## **SPRING PLACE SUBDIVISION**

The plat illustrates the proposed 0.6 acre  $\pm$ , 2 lot subdivision which is located on the East side of South McGregor Avenue, 280' $\pm$  South of the East terminus of Turnout Lane, and is in Council District 5. The applicant states that the subdivision is served by both public water and sanitary sewer.

The purpose of this application is to subdivide one parcel into two lots. The site is currently developed with one single-family residence.

## SPRING PLACE SUBDIVISION CROYDON RD -S-MGGREGOR-AVE TURNOUT LN R SITE LOT 2 RADNORAVE R DATE December 21, 2006 APPLICATION NUMBER \_ NTS

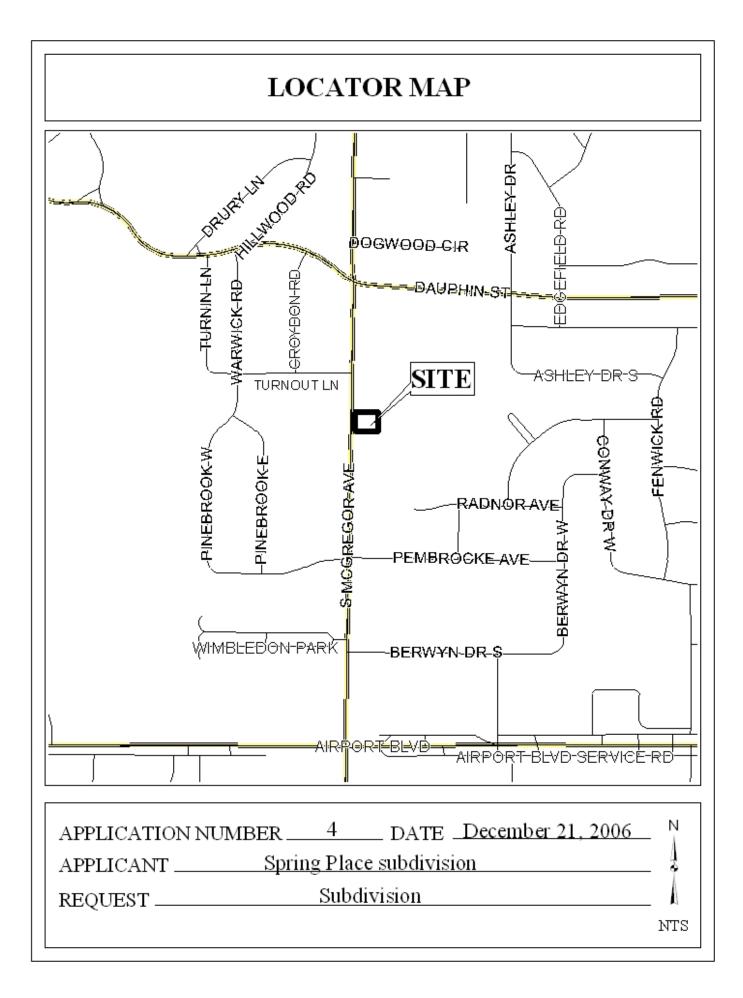
The site fronts onto South McGregor Avenue, a proposed major street. The existing right-of-way at this location is 60 feet in width, while the recommended width listed in the Major Street Plan component of the Comprehensive Plan is 80 feet at this location. Therefore the 25-foot minimum building setback line depicted on the plat should be adjusted to reflect a future right-of-way width of 40 feet, as measured from the centerline of South McGregor Avenue.

Access management is a concern due to the 75 feet  $\pm$  of frontage for each lot on a proposed major street. Each lot should be limited to one curb-cut, with the size, design and location to be approved by Traffic Engineering, and in conformance with AASHTO standards.

The existing residence on the site will be split by the proposed subdivision, thus the structure should either be moved or demolished, prior to the signing of the final plat. Proper permitting will be required.

Based on the preceding, the plat is recommended for Tentative Approval, subject to the following conditions: 1) adjustment of the 25-foot minimum building setback line to reflect a future right-of-way width of 40 feet, as measured from the centerline of South McGregor Avenue; 2) placement of a note on the plat stating that each lot is limited to one curb-cut onto South McGregor Avenue, with the size, design and location to be approved by Traffic Engineering, and comply with AASHTO standards; 3) labeling of each lot with its size in square feet, or provision of a table on the plat with the same information; 4) provision of evidence of permits to move or demolish the existing structure(s) prior to the signing of the final plat; and 5) full compliance with all other municipal codes and ordinances.
